**Subject: Rio Salado Town Lake Dam (07.66)
December 4, 2009 Dam Safety Inspection Report
Finding of No Safety Deficiency**

**ARIZONA DEPARTMENT OF WATER RESOURCES
OFFICE OF WATER ENGINEERING – DAM SAFETY SECTION
INFLATABLE RUBBER DAM / CONCRETE DAM SAFETY INSPECTION REPORT**

SID: 07.66	DAM NAME: Rio Salado (Tempe Town Lake)	TYPE: Inflatable Rubber	PURPOSE: Recreation	NOT APPLICABLE	NO	YES	MONITOR	REPAIR	INVESTIGATE	
CONTACT(S): Basil Boyd, R.G. – City of Tempe			REPORT DATE: December 17, 2009							
INSPECTED BY: Craig Brown <i>CB</i>			INSPECTION DATE: December 4, 2009							
REVIEWED BY: Michael Johnson, PhD., P.E. <i>MJ</i>			DATE: 1-7-10							
DESIGN DAM CREST ELEVATION: 1,148		DESIGN SPILLWAY CREST ELEVATION: 1,148								
DESIGN TOTAL FREEBOARD (FT): 16		MEASURED TOTAL FREEBOARD (FT): N/A								
STATUTORY DAM HEIGHT (FT): 16		STRUCTURAL HEIGHT (FT): 40								
DAM CREST LENGTH (FT): 902	UPSTREAM SLOPE: 0	DOWNSTREAM SLOPE: 0								
DAM CREST WIDTH (FT): 16	GPS: Lat.: 33°26'01.4" Long.: 111°56'56.0"	WATER RIGHTS: 33-96623								
RSRVR. AREA (AC): 214	RSRVR. STORAGE (AC-FT): 2,419	MAX. STORAGE (AC-FT): 2,846								
INFLOW DESIGN FLOOD / SAFE FLOOD-PASSING CAPACITY: .25 P

PHOTO NUMBER: 10
PHOTO DIRECTION: Down
DESCRIPTION: One of the piezometers located in the foundation slab below bladder #4.

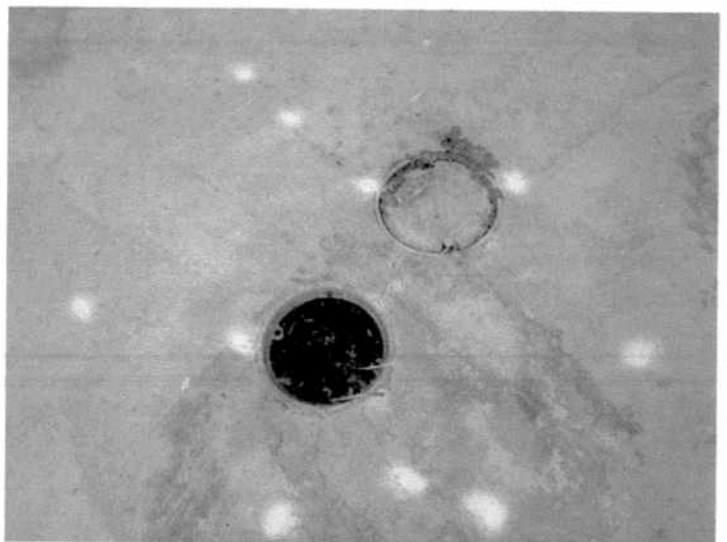
b. Any repair or replacement required? Describe: 8 of the downstream piezometers were damaged during the high flows in early 2005 and are no longer functional. Specifically: DS-2, DS-6, DS-7, DS-9, DS-17, DS-18, DS-19, and DS-20. There are plans to replace all of the damaged piezometers located in the foundation slab. Piezometers located within the stilling basin do not require replacement. See photo 10.						X		X

PHOTO NUMBER: 16
PHOTO DIRECTION: West
DESCRIPTION: Toward downstream below bladder #1 and the area of missing riprap. There are plans to replace the riprap in the near future.

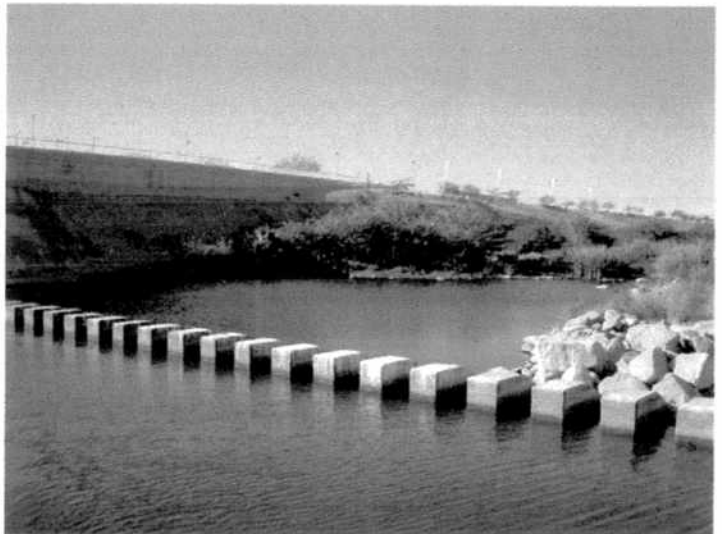
12. DOWNSTREAM DAMS – SPLASH PAD APRON & STILLING BASIN 35-ft. wide x 1.5-ft. thick reinforced concrete stilling basin. Rip rap is placed along the entire length of the stilling basin. See photos 5, 9, & 22. During the high flows in early 2005 rip rap was damaged or washed away downstream below bladders 2-4 and had to be replaced. Riprap has been replaced below bladders 2-3 and has not been replaced below bladder # 4. There are plans to replace the riprap in the near future. See photo 16.

PHOTO NUMBER: 20
PHOTO DIRECTION: South
DESCRIPTION: 108-inch storm drain located under the Tempe Center for the Arts building.

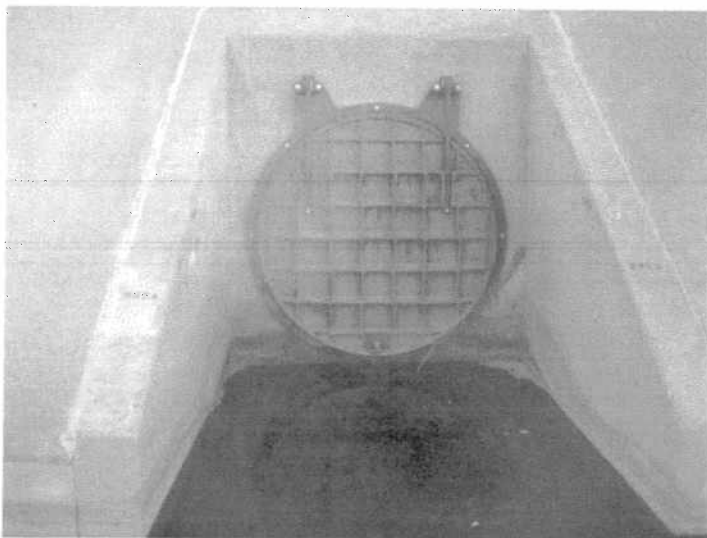
- As recommended in the 2006 ADWR report, the integrity of the 108-inch storm drain pipe should be evaluated following completion of the Tempe Center of the Performing Arts building currently under construction.

PHOTO NUMBER: 21
PHOTO DIRECTION: Down
DESCRIPTION: Eroded section of concrete at the left (south) abutment of the downstream dam located just below the 108-inch storm drain.

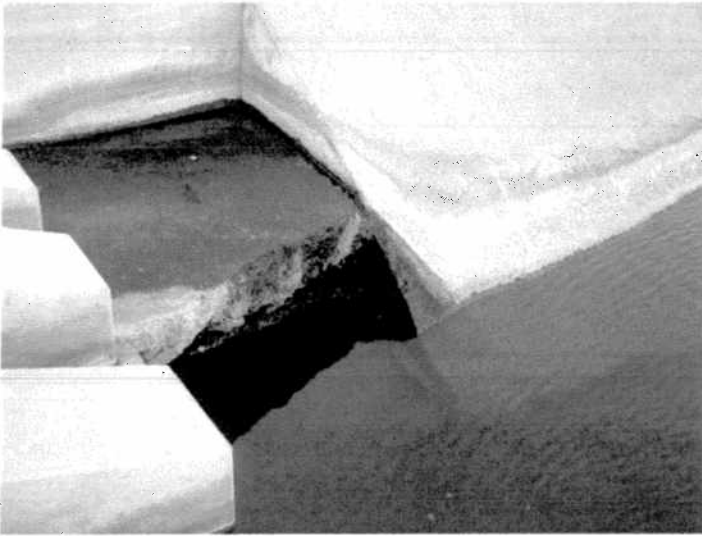
h. Erosion? Erosion of the concrete was observed in a small area just below the baffle blocks and the 108-inch storm drain evidently caused by the high flows. This area should be repaired to prevent any further damage due to subsequent flows. See photo 21.						X		X
